DESIGN CB	DRAWN BY CB	DART AEROSPACE LTD HAWKESBURY, ONTARIO, CANADA	
CHECKED CE	APPROVED #	DRAWING NO. DSI 9363	REV. A SHEET 1 OF 1
DATE 07.01.19		TITLE SHIM KIT	SCALE NTS
A	07.01.19	NEW ISSUE

DART SERVICE INSTRUCTION

TO AMEND INSTALLATION INSTRUCTIONS IIN-D412-694 REV. B AND INSTRUCTIONS FOR CONTINUED
AIRWORTHINESS ICA-D412-694 REV. 1
REF. CANADIAN STC: SH05-10
REF. FAA STC: SR02086NY

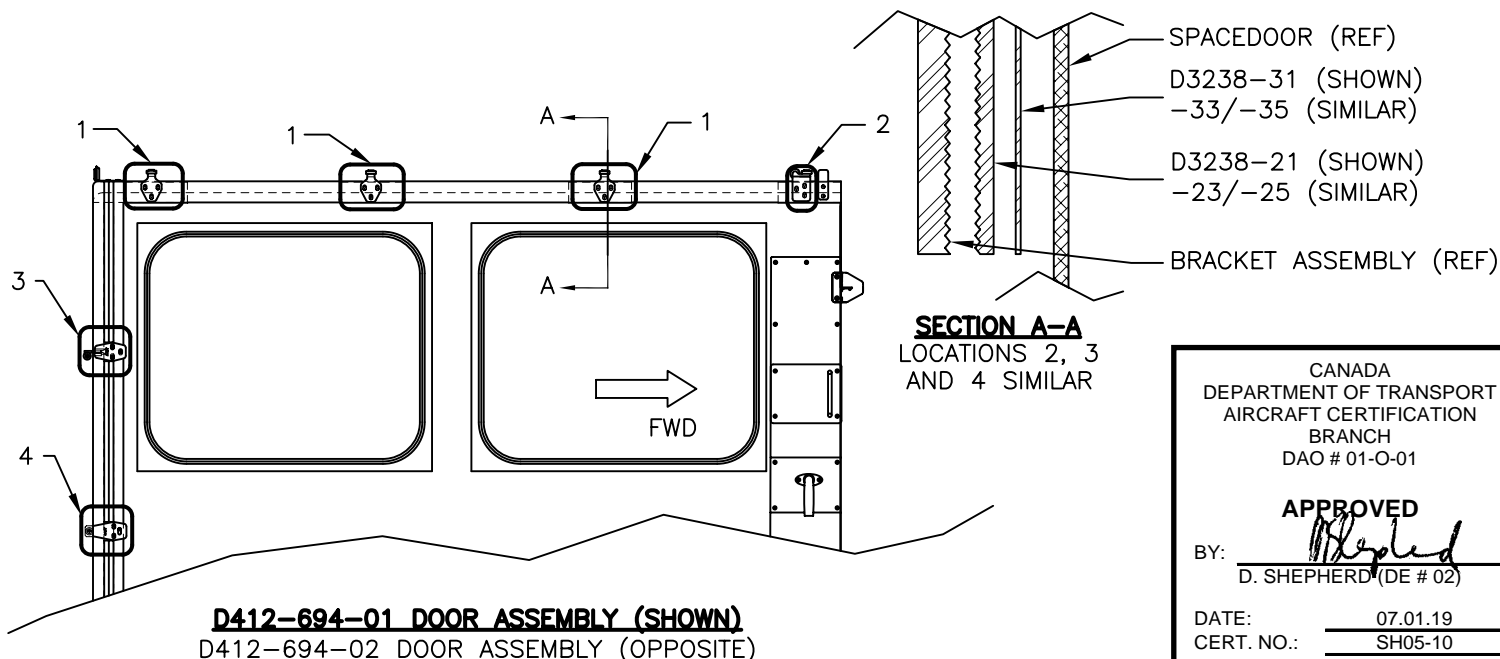
Dart has created the optional DSI-9363-011 Shim Kit that may be installed between the D3121-041/-043/-044, D3183-041/-042 and D3137-041 Bracket Assemblies and the Spacedoor™ to improve grip between the Bracket Assemblies and the Spacedoor™. This kit may be installed as a replacement for or in addition to the AN960JD10 Washers and/or the D3090-1/-3 Shims used to shim the Bracket Assemblies as described in the Installation Instructions.

The serrated faces of the D3238-21/-23/-25 Plates should be installed against the serrated faces of the Bracket Assemblies to ensure positive locking as shown in **Section A-A**. The D3238-31/-33/-35 Plates, the AN960JD10 Washers and the D3090-1/-3 Shims can be installed as required between the D3238-21/-23/-25 Plates and the Spacedoor™ to achieve good door alignment.

The Table and Figure below show the location, the quantity and the part number of each Plate and the corresponding Bracket Assemblies on the Spacedoor™.
